LETTER OF SUBMITTAL
KFM Skyway Project # 04-012024

Subject: KFM - NCR #53 - Arc Strikes on Orthotropic Tub Deck

NON-CONFORMANCE REPORT	53
-------------------------------	-----------

Subject: Response to KFM-SUB-006142R00: KFM NCR #53 - Arc Strikes on Orthotropic Tub Deck

WEST END

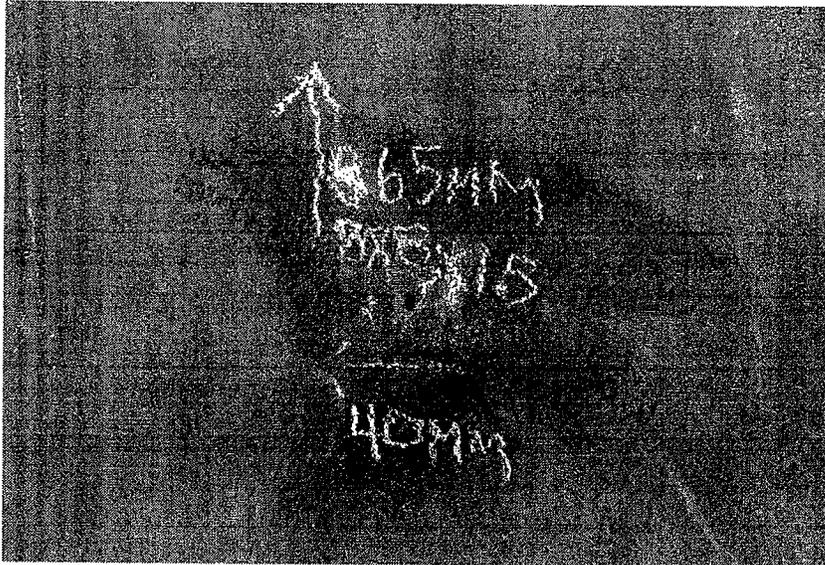
Report of Condition/Cause of Non-Conformance: While welding restrainer plates down to the orthotropic tub deck the welder put his welding stinger down on the deck and inadvertently created an arc strike. The location was on the west end of the tub 226cm west of BM705 and 33cm south of the web frame. On the east end of the tub 865mm east of BM815 and 40mm north of the web frame one of the welding leads had a bare spot and also created an arc strike. The approximate size of both arc strikes was 8mm X 8mm X 1.5mm. (See attached photos)
--

The Engineer has reviewed KFM-SUB-006142R00: KFM NCR #53 - Arc Strikes on Orthotropic Tub Deck and it is not approved. The subject submittal contains insufficient information to resolve the nonconformance. In addition to the proposed resolution, the Engineer requests the following information:

1. What is the thickness profile of the deck plate at the location pertaining to this repair?
2. What is the depth of the excavation and/or grinding required to complete the repair?

Recommended Corrective Action: Recommend carefully grinding the arc strike away, fair out the adjacent surfaces on a slope not steeper than 1 into the metal to 10 along the surface. (ref: AWS D1.5 1996 12.13.3) and Magnetic Particle Test (MT) to verify metal soundness after the areas have cooled to ambient temperature for at least 24 hours. Further recommend to carefully inspect all welding leads in or on the orthotropic tub to ensure there are no bare spots in the insulation that might create more arc strikes.				
<table style="width: 100%; border: none;"> <tr> <td style="width: 25%; border: none;">Originator Signature:  Dennis Winter</td> <td style="width: 15%; border: none;">Date: 2/4/06</td> <td style="width: 25%; border: none;">Superintendent Signature:  Derek Stark</td> <td style="width: 35%; border: none;">Date: 2/4/06</td> </tr> </table>	Originator Signature:  Dennis Winter	Date: 2/4/06	Superintendent Signature:  Derek Stark	Date: 2/4/06
Originator Signature:  Dennis Winter	Date: 2/4/06	Superintendent Signature:  Derek Stark	Date: 2/4/06

Recommended Corrective Action: The top deck plate thickness is 16mm; therefore, repairs will be ground and rewelded in accordance with Critical Weld Repair Report # 394. In the future all welding leads will be carefully inspected to prevent this from happening again.
